Bulletin No. 2003-04

Incorrect Door Knob Bushing On 21/24 Gator Mounts

a - Knob
b - Bushing
c - Washer
d - Door

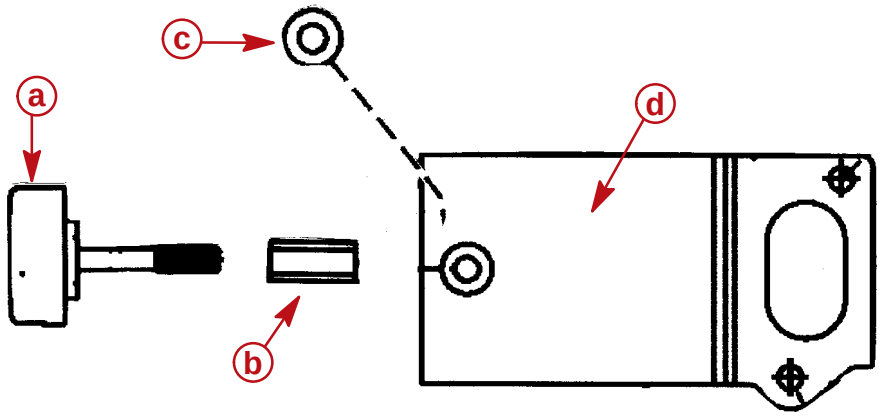
Manufacturing may have installed a plastic door knob bushing on the above listed mounts rather than the normal metal bushing.

If the plastic door knob bushing is found in the above listed mounts, replace the bushing with a metal door knob bushing.
